RE: UISCE EIREANN

MARITIME USAGE LICENCE APPLICATION REFERENCE: MUL230015

We refer to your correspondence dated 04/09/2025 regarding the above-referenced Maritime Usage Licence application. We note the request for additional information under Section 117(3) of the Maritime Area Planning Act 2021 and have provided a respond to each of the points raised below.

5. Bathymetric Methods

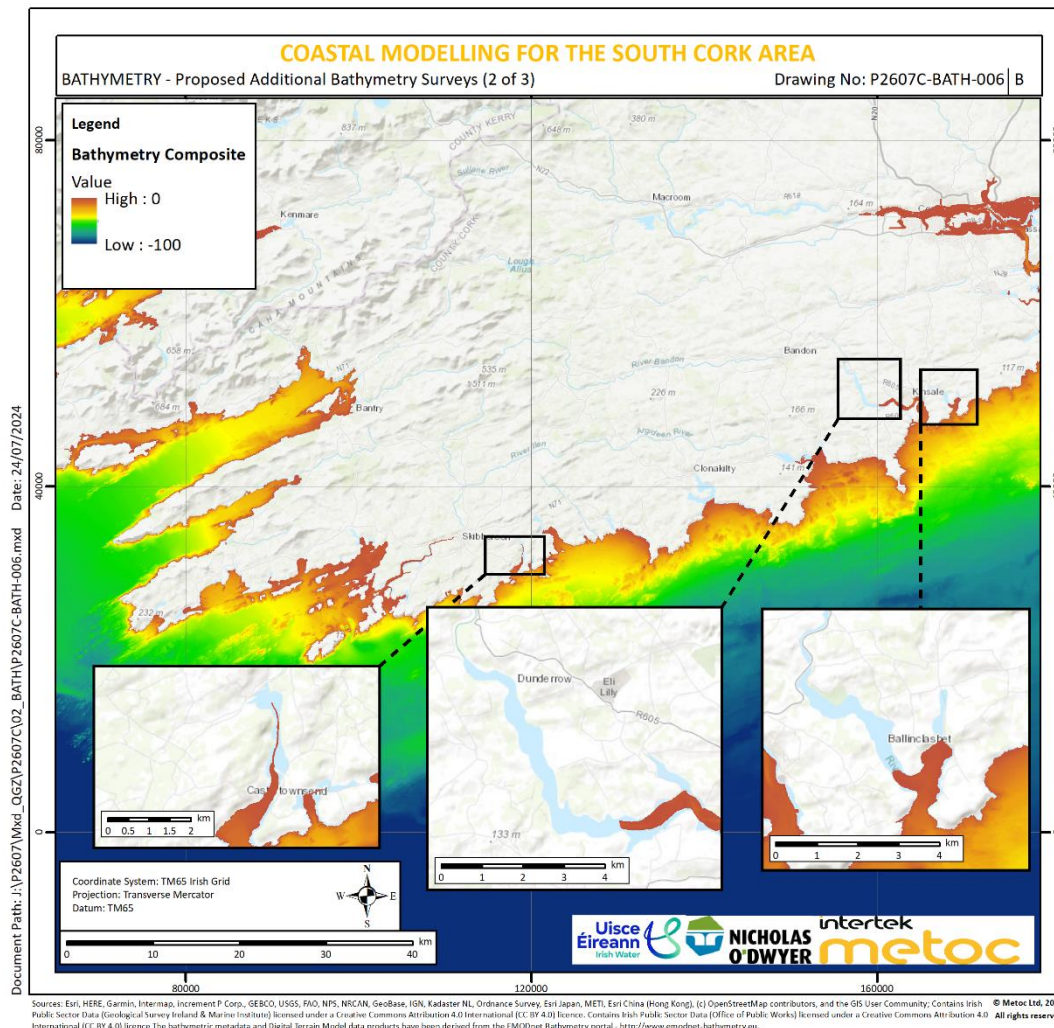
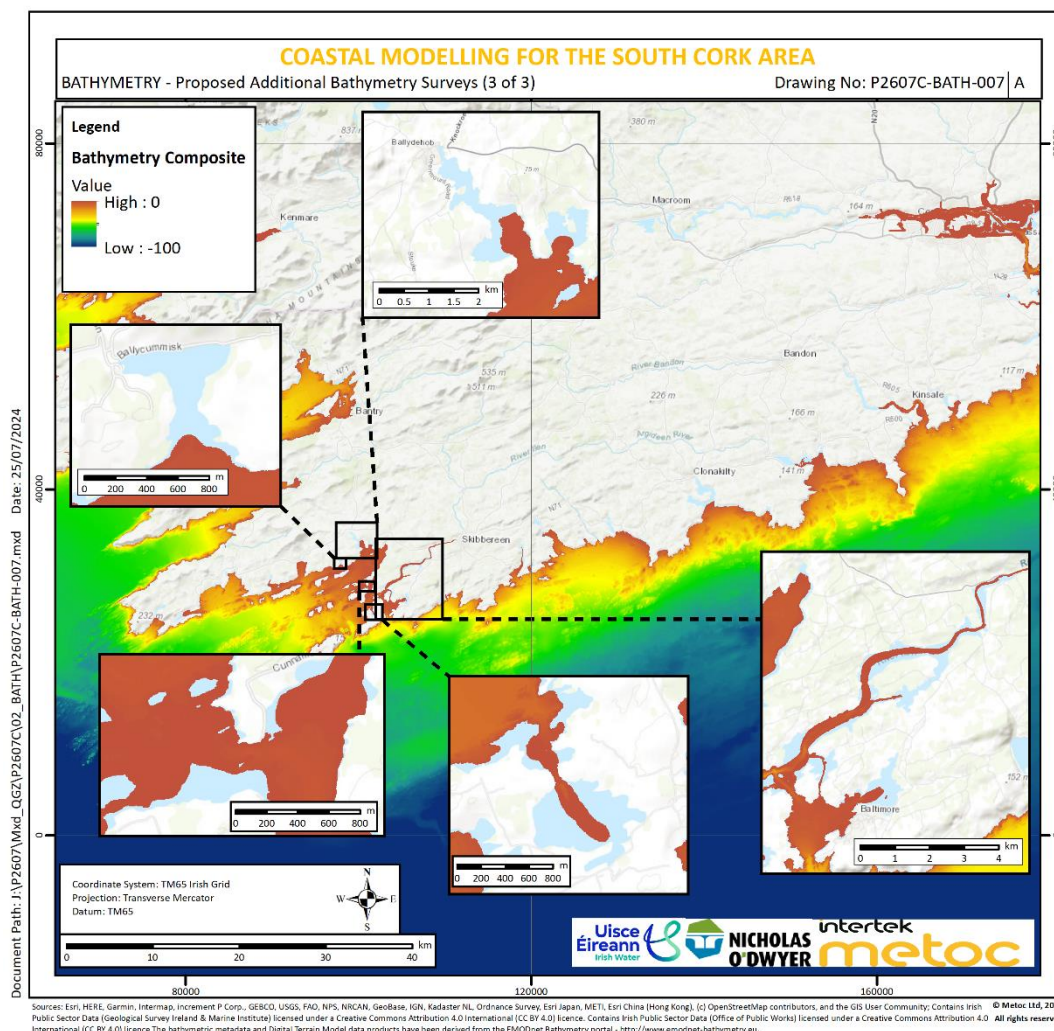
Bathymetric surveying may be required in intertidal areas where no existing valid data was found to be available. Refer to the figures appended to this response for likely locations. The precise areas which will be subject to vessel-based surveying vs other methods will be determined upon mobilisation. Reference to all means of data collection to be adopted was included in the application to provide context and illustrate that all efforts are being made to minimise vessel based surveying.
